# RESPONSE to the Recommendations of the Experimental Readiness Review for the CPP and NPP Experiments

-----  
Hall D E12-13-008/ E12-13-008A  
Experiment Readiness Review  
Jefferson Lab February 10, 2021 – remote

## **Report** **Experiment Readiness Review for the Hall D experiments** **E12-13-008/E12-13-008A**

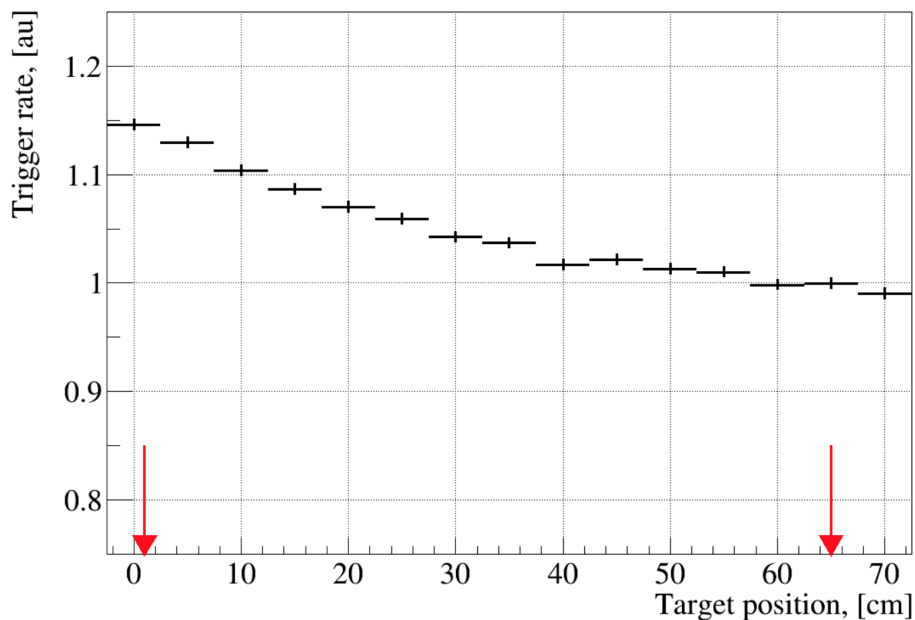
Provide the real measured rates and the details of how the 30 kHz rate was estimated. The provided estimates (for CPP and NPP) were based on the measured rates with the target at the nominal position. How much rate increase is expected from having the target ~60 cm upstream, including the rate from additional air downstream of the target.

- The analysis of the beam tests and trigger rates are provided in GlueX-doc-4796 (<https://hallweb.jlab.org/doc-private/DocDB/ShowDocument?docid=4796>).
- The effect of having the target 64 cm upstream of the nominal GlueX target increases the rates by about 15%. The rates as a function of target position are shown in the following plot computed with our hdgeant3 simulation of the experiment. The arrows indicate the nominal GlueX target center (65 cm) and the proposed CPP target position (1 cm).
